# Tech Tip

## Stainless Steel Braided From Compressor to Air Dryer

FIGURE #2

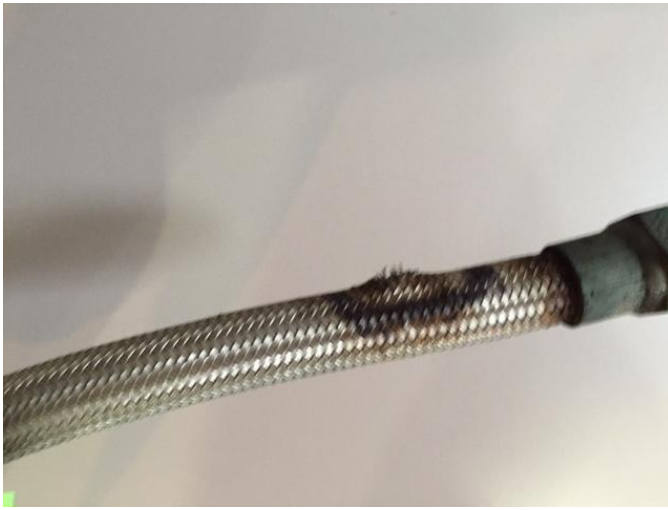
- Complaint –** We found that the stainless steel braided line from the compressor to the air dryer had a spot where the braids are broken and the rubber hose is starting to “bulge” through, please see Figures #1, #2 & #3.
- Cause –** We believe after reviewing several units that the cause maybe associated with the plastic tag which is on the hose as identification Please See Figure #4. We suspect that road chemicals trapped beneath the tag along with the varying change in temperature as the units cycles air compressor cycles may be what is leading to the issue.
- Correction –** Remove the tag from the line
